Editorial improvements to GRE/2023/27-Rev.1

The modifications are highlighted in red in comparison to GRE/2023/27-Rev.1

Figure 1
Charging mode configuration for Annex 4

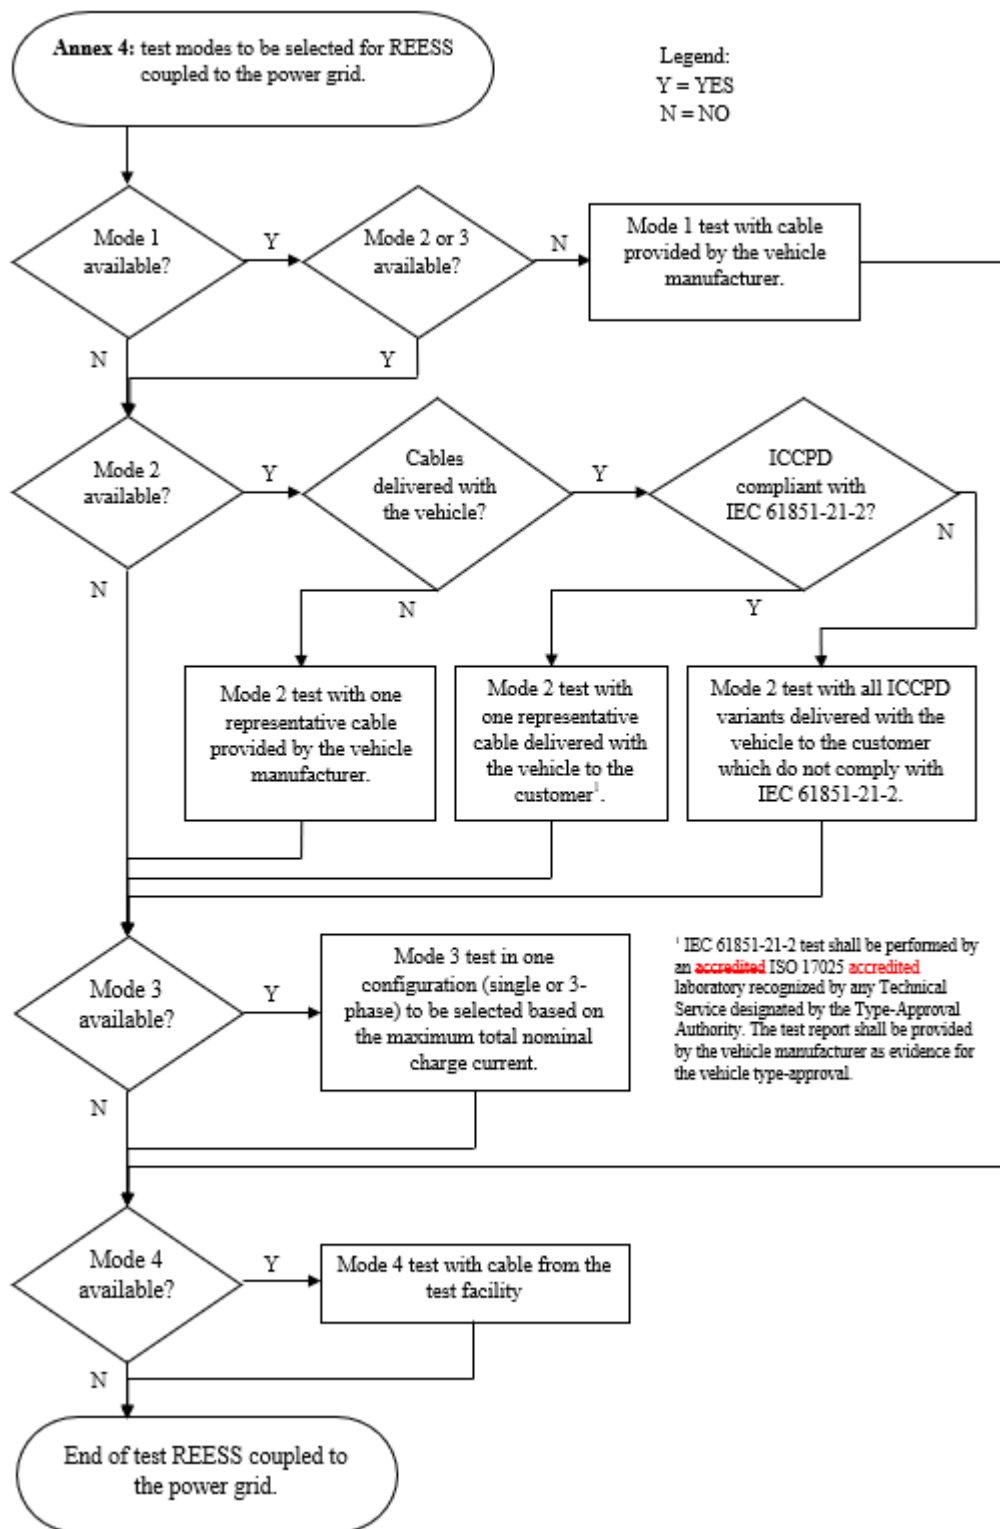
The vehicle shall be tested in the charging mode configuration (if available on vehicle) as defined in flowchart of figure 1

If the current consumption can be adjusted, then the current shall be set to at least 80 per cent of its ~~nominal~~ **maximum rated charging/input current** value for AC charging.

If the current consumption can be adjusted, then the current shall be set to at least ~~80~~ **20** per cent of its nominal value **or to a minimum of 16 A (if the 20 per cent of its nominal value cannot be achieved in the test facility)** for DC charging unless another value is agreed with the type approval authorities.

Figure 1

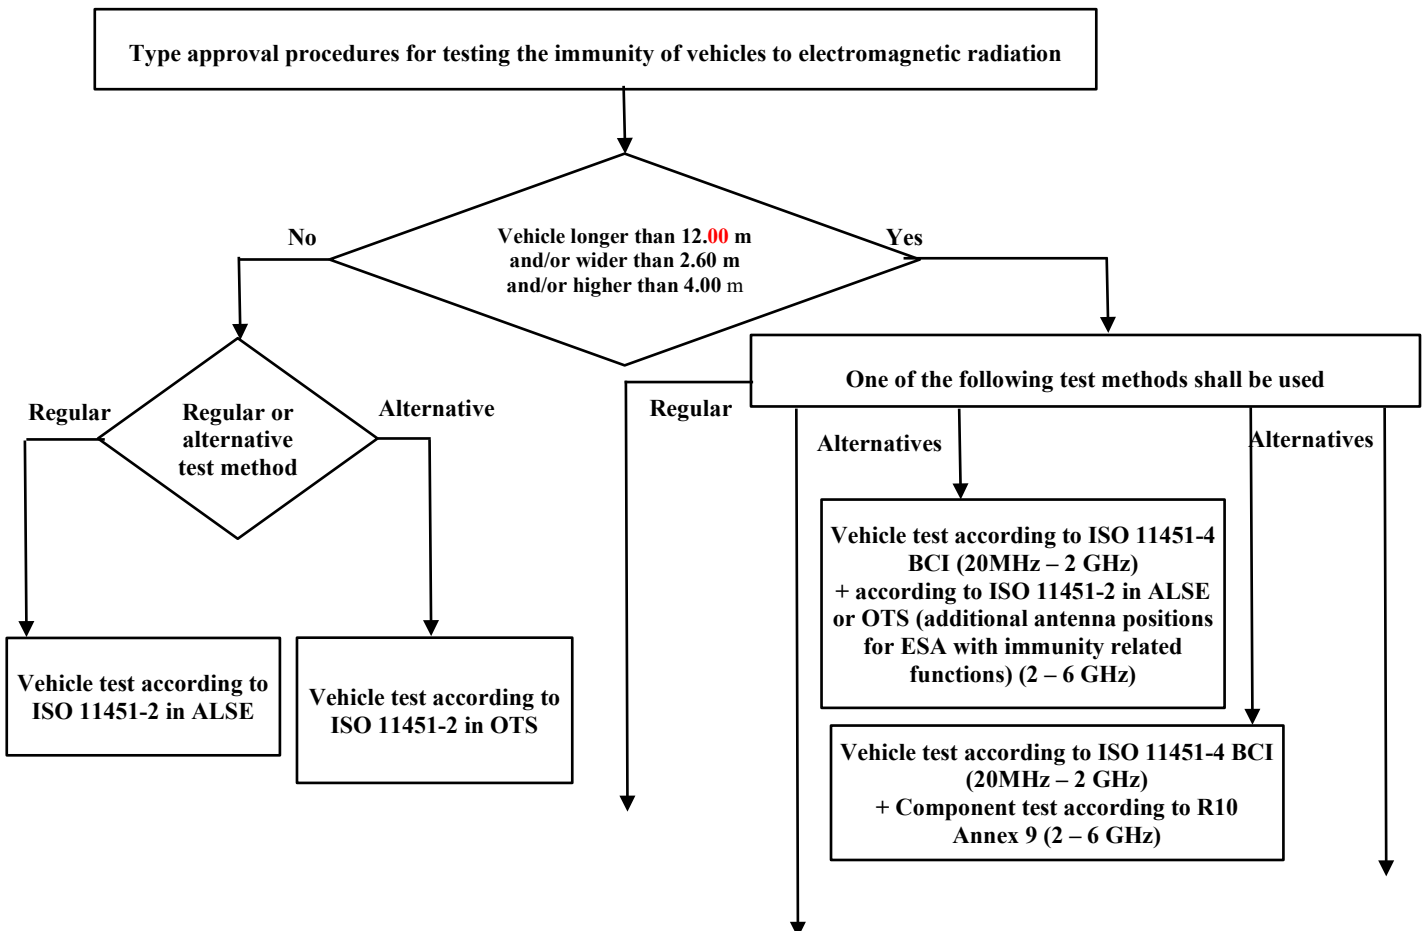
"1.4 Applicability of test methods:

**Vehicle test according to ISO 11451-2 in ALSE
(additional antenna positions for ESA with
immunity related functions)**

**Vehicle test according to ISO 11451-2 in OTS (additional
antenna positions for ESA with immunity related
functions)**

**Vehicle test according to ISO 11451-2 in ALSE or
OTS (20MHz – 6 GHz)
+ Component test according to R10 Annex 9 (20
MHz – 6 GHz) for each ESA with immunity related
functions outside antenna beamwidth**

Figure 1
Charging mode configuration for Annex 11

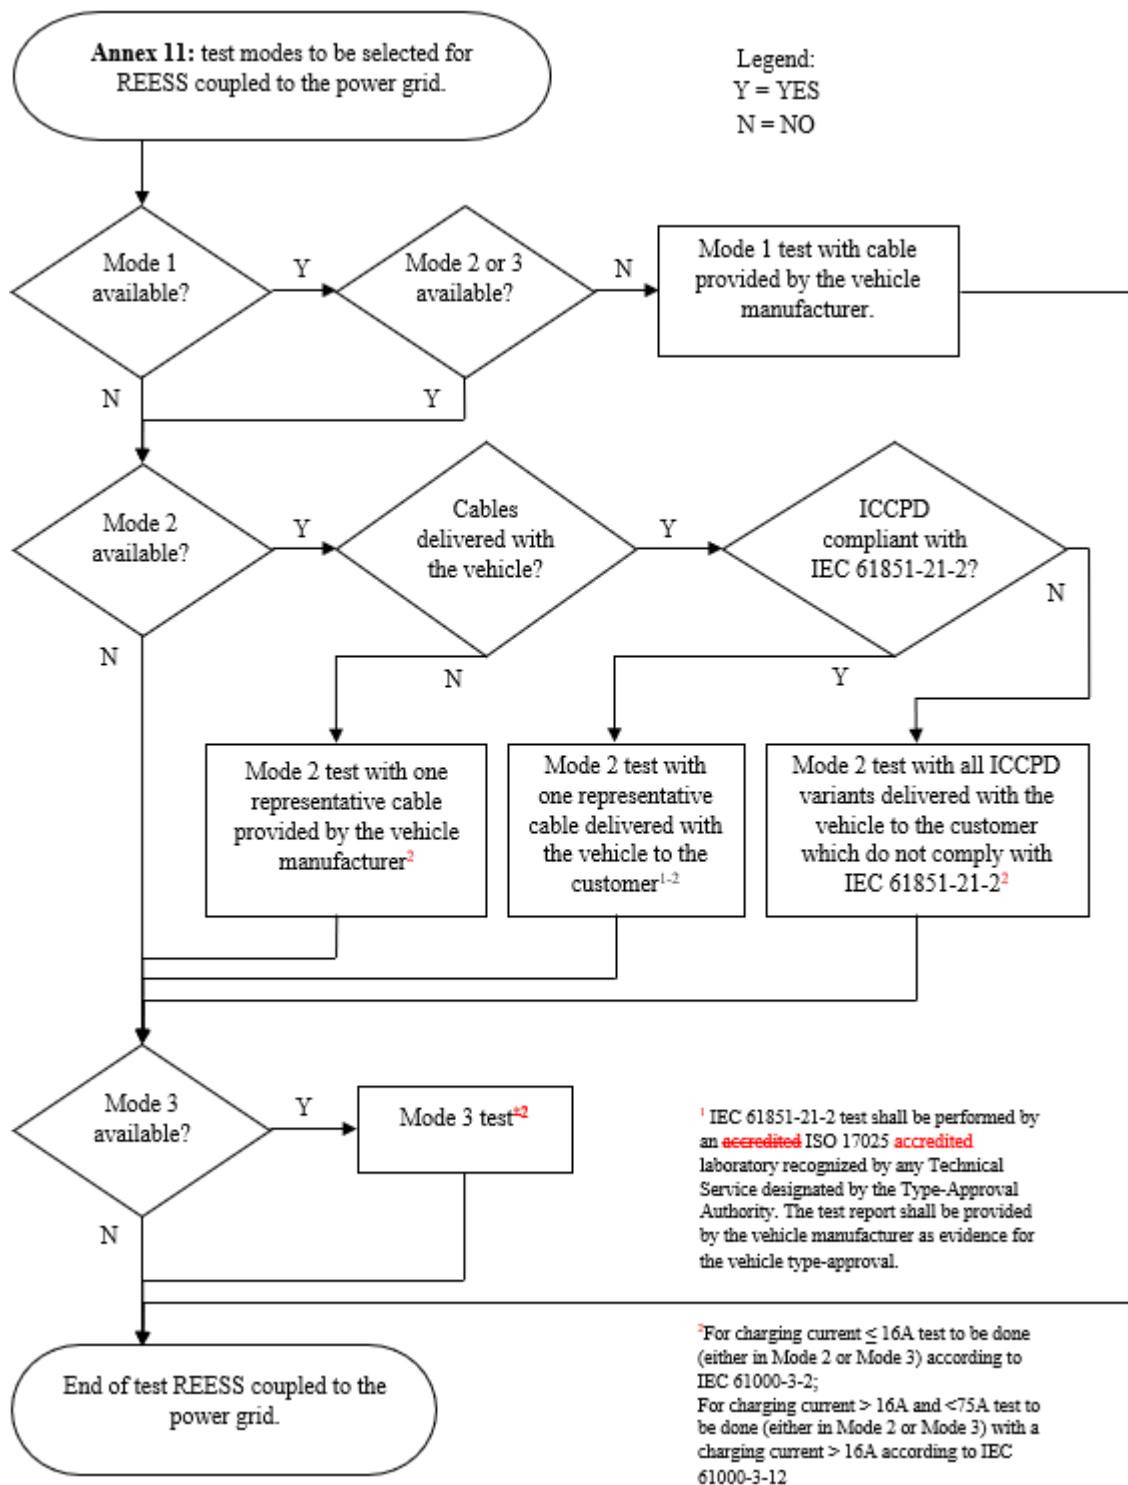
The vehicle shall be tested in the charging mode configuration (if available on vehicle) as defined in flowchart of figure 1

The state of charge (SOC) of the traction battery shall be kept between 20 per cent and 80 per cent of the maximum SOC during the whole time duration of the measurement (this may lead to the measurement being splitting into different time slots with the need to discharge the vehicle's traction battery before starting the next time slot). If the current consumption can be adjusted, then the current shall be set to at least 80 per cent of its ~~nominal~~ **maximum rated charging/input current** value for AC charging.

Figure 1
Charging mode configuration for Annex 12

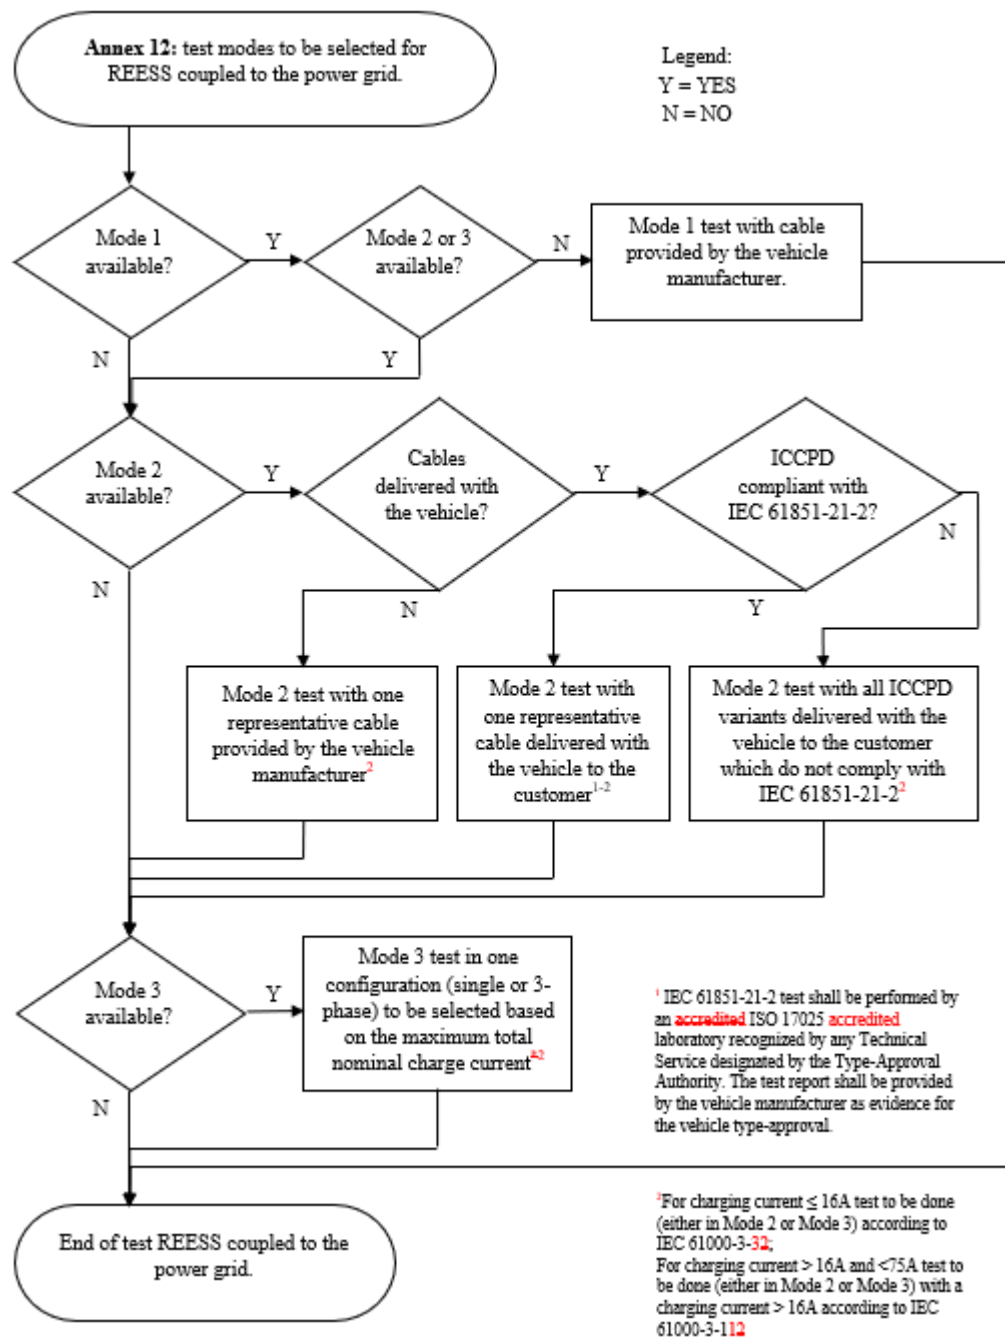
The vehicle shall be tested in the charging mode configuration (if available on vehicle) as defined in flowchart of figure 1

The state of charge (SOC) of the traction battery shall be kept between 20 per cent and 80 per cent of the maximum SOC during the whole time duration of the measurement (this may lead to the measurement being splitting into different time slots with the need to discharge the vehicle's traction battery before starting the next time slot). If the current consumption can be adjusted, then the current shall be set to at least 80 per cent of its ~~nominal~~ **maximum rated charging/input current** value for AC charging.

Figure 1: Charging mode configuration for Annex 13

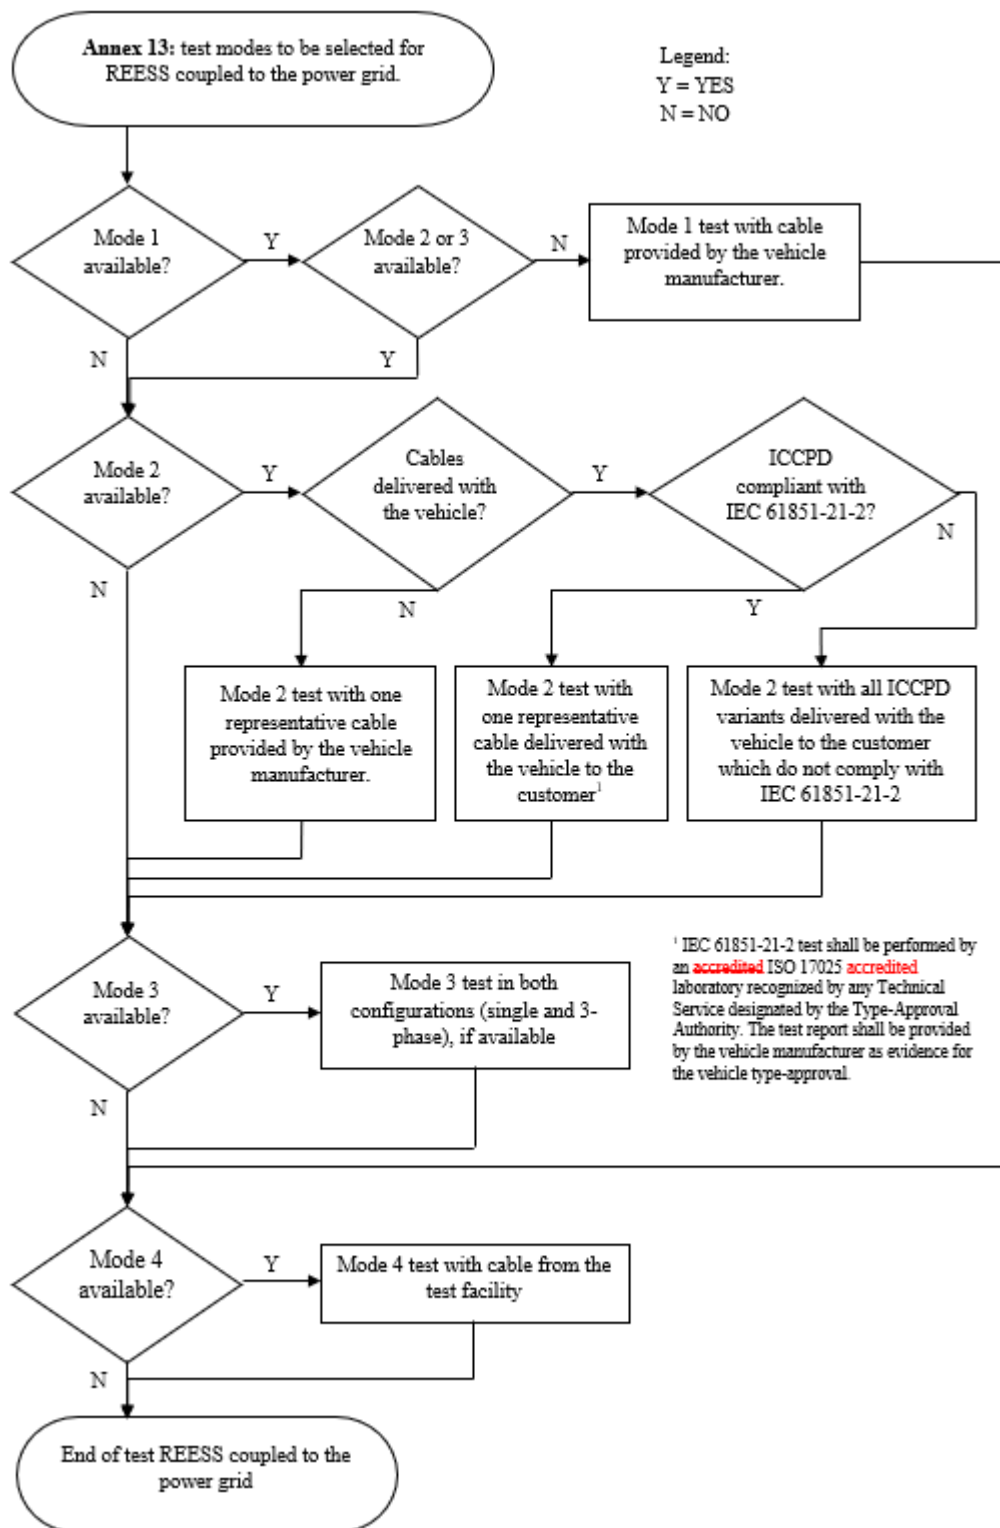
The vehicle shall be tested in the charging mode configuration (if available on vehicle) as defined in flowchart of figure 1

If the current consumption can be adjusted, then the current shall be set to at least 80 per cent of its ~~nominal~~ **maximum rated charging/input current** value for AC charging.

If the current consumption can be adjusted, then the current shall be set to at least ~~80~~ **20** per cent of its nominal value **or to a minimum of 16 A (if the 20 per cent of its nominal value cannot be achieved in the test facility) for DC charging unless another value is agreed with the Type-Approval Authorities.**

Figure 1
Charging mode configuration for Annex 15"

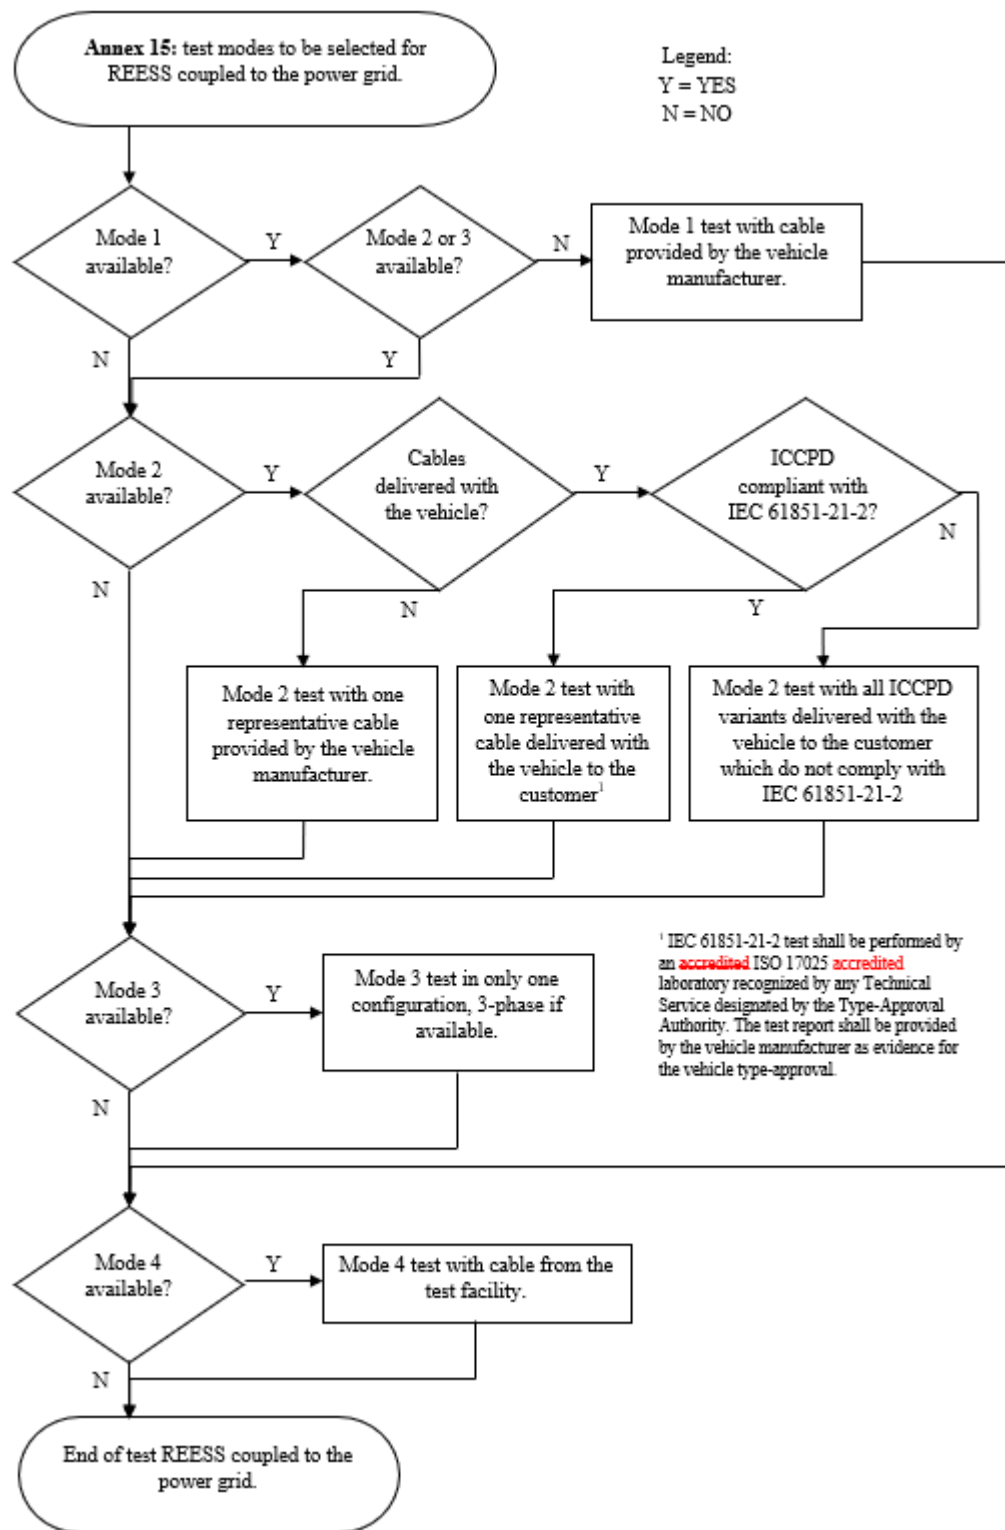
The vehicle shall be tested in the charging mode configuration (if available on vehicle) as defined in flowchart of figure 1

Figure 1
Charging mode configuration for Annex 16"

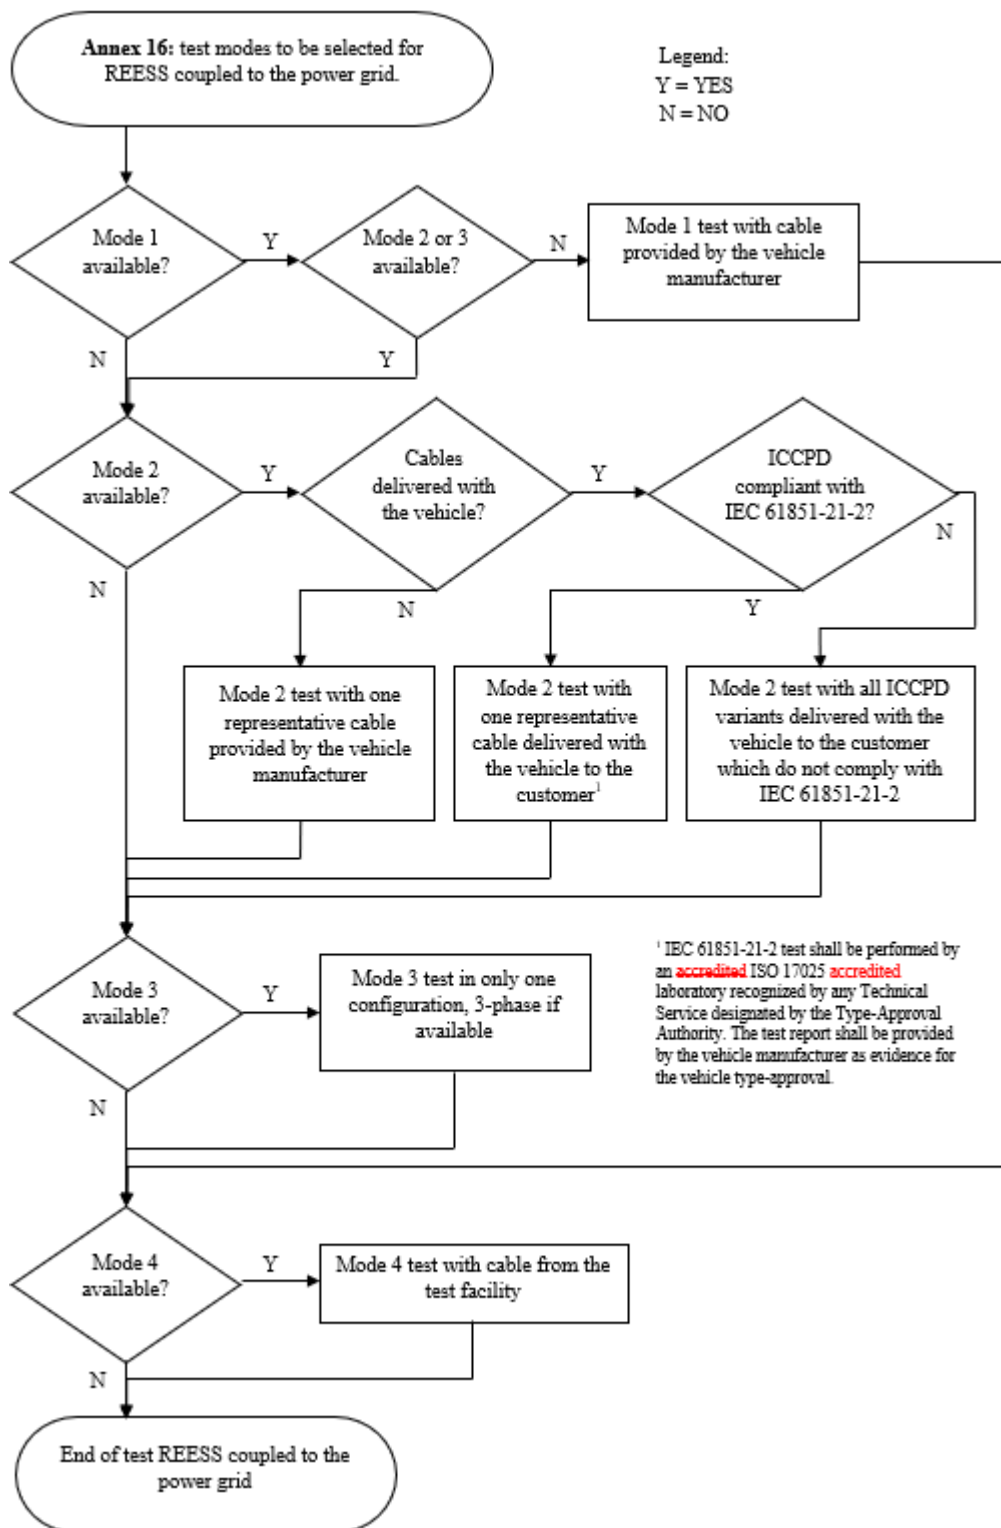
The vehicle shall be tested in the charging mode configuration (if available on vehicle) as defined in flowchart of figure 1
